97V-131 (01)

**RE: Recall Campaign -- Cruise Control and Throttle Cables
1992-97 BMW 3-Carline, 1989-95 BMW 5-Carline,
1993-97 BMW 740i, 740iL, 1994-97 BMW 840Ci**

Group 35 Pedals	Bulletin Number 35 01 97 Page 1 of 6	Woodcliff Lake, NJ October 1997 Product Engineering
--------------------	--------------------------------------------	-----------------------------------------------------------

SUBJECT: Recall Campaign 97V-131

Cruise Control Cable at Throttle Valve

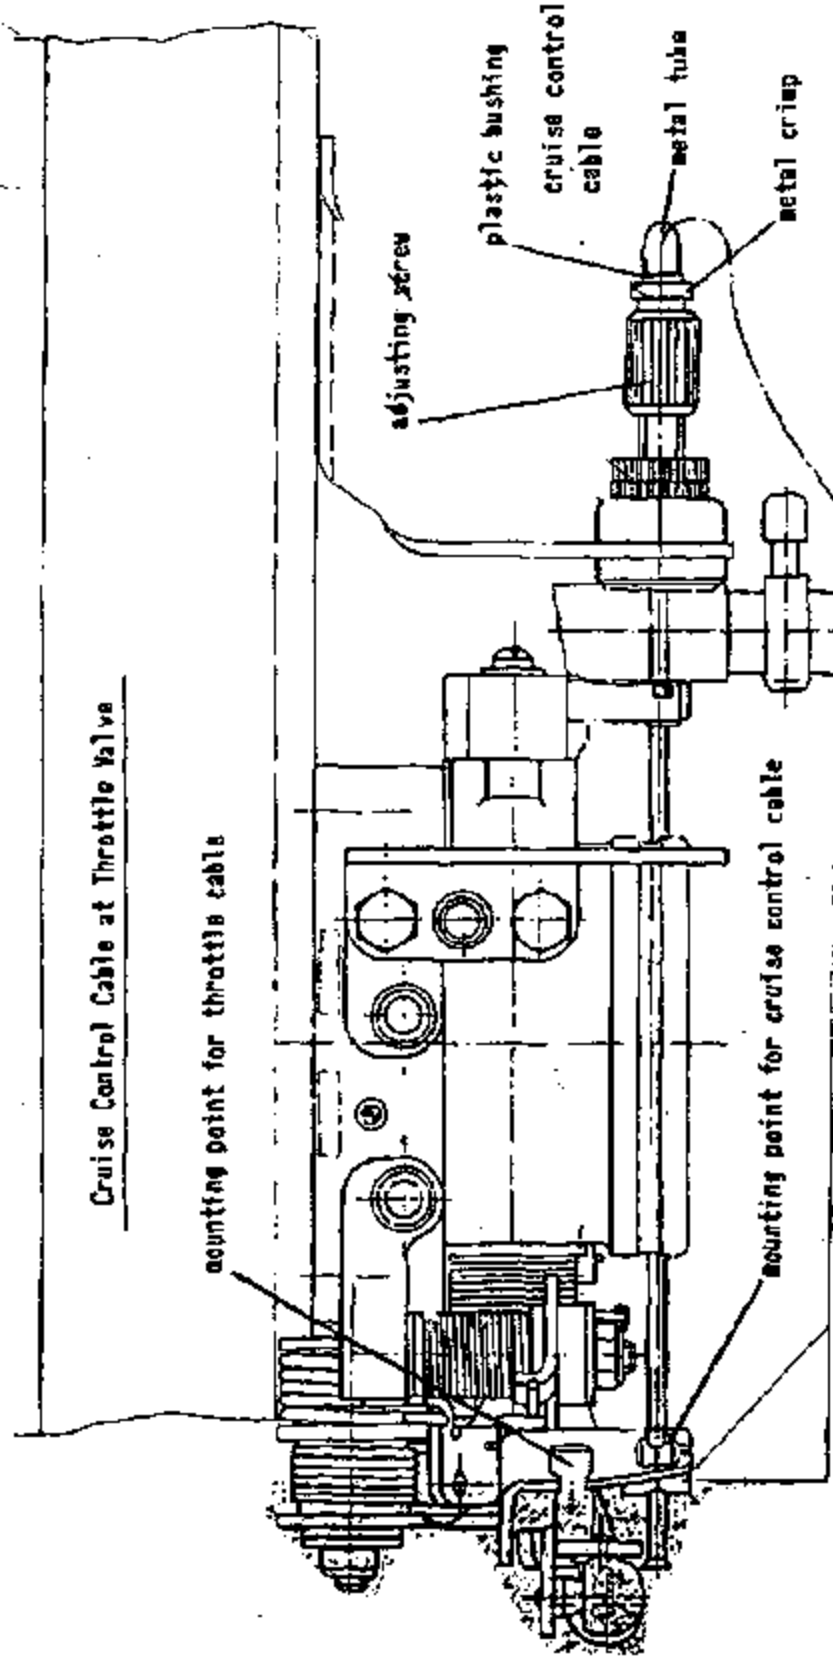
3. The number of vehicles potentially containing the defect is approximately 410,000.
4. The percentage of vehicles estimated to actually contain the defect is less than 1%.
5. The potential defect involves the cruise control and throttle cables of the subject vehicles. Both Bowden cables are attached to the same throttle valve actuating lever at the throttle housing. See attached drawing. It is possible that the plastic bushing on either cable, at the adjusting screw near the throttle housing, could break due to environmental influences coupled with vibration. If this were to occur, the metal outer tube of the cable assembly could become moveable in the bushing.

While it is extremely unlikely that the outer tube of the throttle cable, due to spring forces in that system, could be dislodged from the bushing during operation of the throttle linkage, it is possible that the outer tube of the cruise control cable could do so.

In this case, during application of the throttle pedal without cruise control being engaged, the throttle cable would be under tension while the cruise control would be slack and could dislodge from the bushing. During subsequent release of the pedal, with simultaneous tensioning of the cruise control cable, the outer tube could catch on the edge of the broken bushing, rather than reentering the bushing. This would cause the throttle valve to remain partially open. If this were to occur, a higher-than-normal idle speed would be present in the transmission's Neutral position and the vehicle might not decelerate as expected when the throttle pedal is released.

7. Not applicable
8. BMW will conduct a recall campaign to remedy the defect in the affected vehicles. The remedy will consist of installing a spring steel clip on the outer tube of each cable in the area of the adjusting screw and plastic bushing. The clip will prevent the outer tube from dislodging from the bushing. The clips were implemented in production beginning in early August 1997.

90° curved version cable
(1) Metal Ring

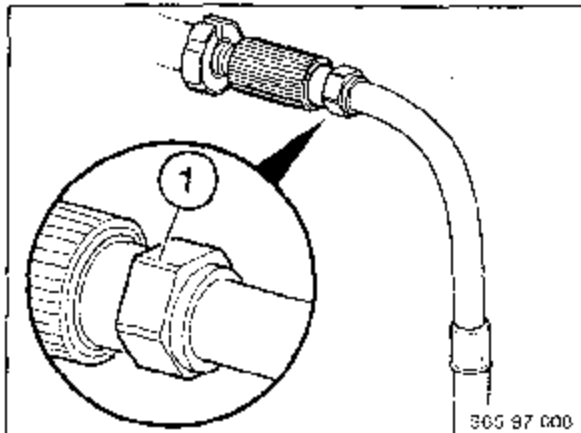
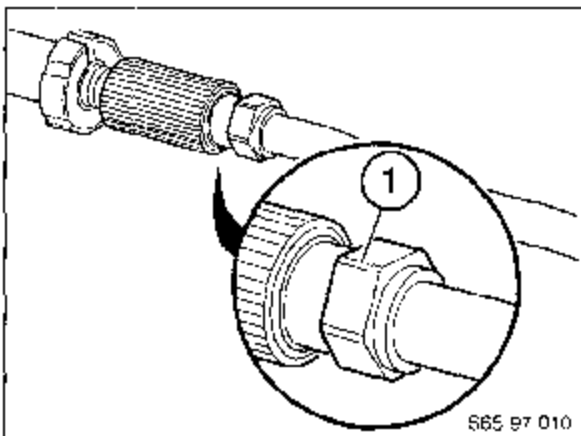
Procedure: Inspect the throttle and cruise control cables to determine if they require installation of the clips. Cars equipped with the M60/M62 engines will have to have the noise insulation cover removed to perform this check. Cables without the metal ring as illustrated below do not need to have the clip installed.

Note: Current production cables are the improved version without the metal ring, so replacement parts will not require installation of the retaining clip.

If a cable has the metal ring as illustrated above, install the proper spring steel clip as illustrated below.

90° curved version cable
Install long spring steel clip (1), part number 35 40 1 165 394 as illustrated.

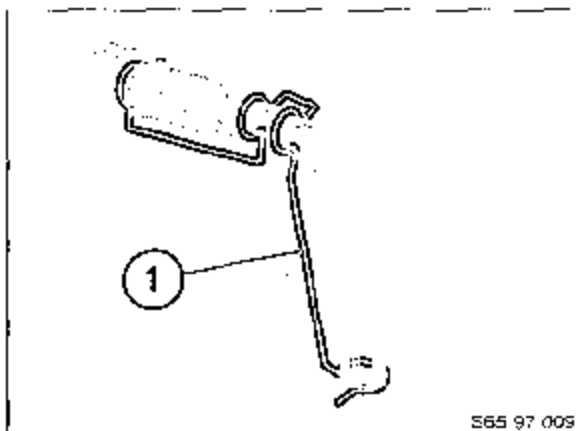
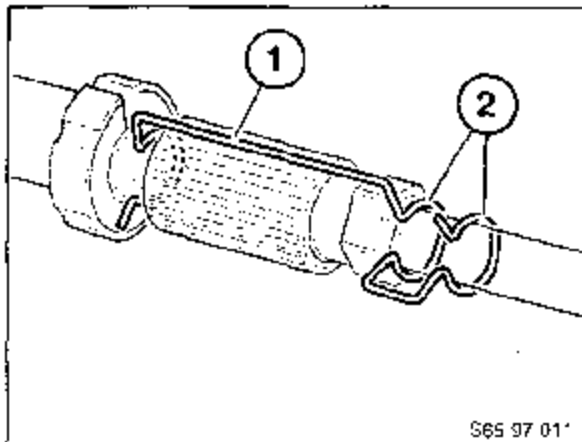
Note: Even if the plastic bushings are cracked or broken, it is not necessary to replace the cable. The spring steel clips will hold the cable in the proper position.

Straight version cable

Install short spring steel clip (1), part number 35 40 1 165 393 as illustrated. Make certain that the double clip end (2) is on the outer housing of the cable.
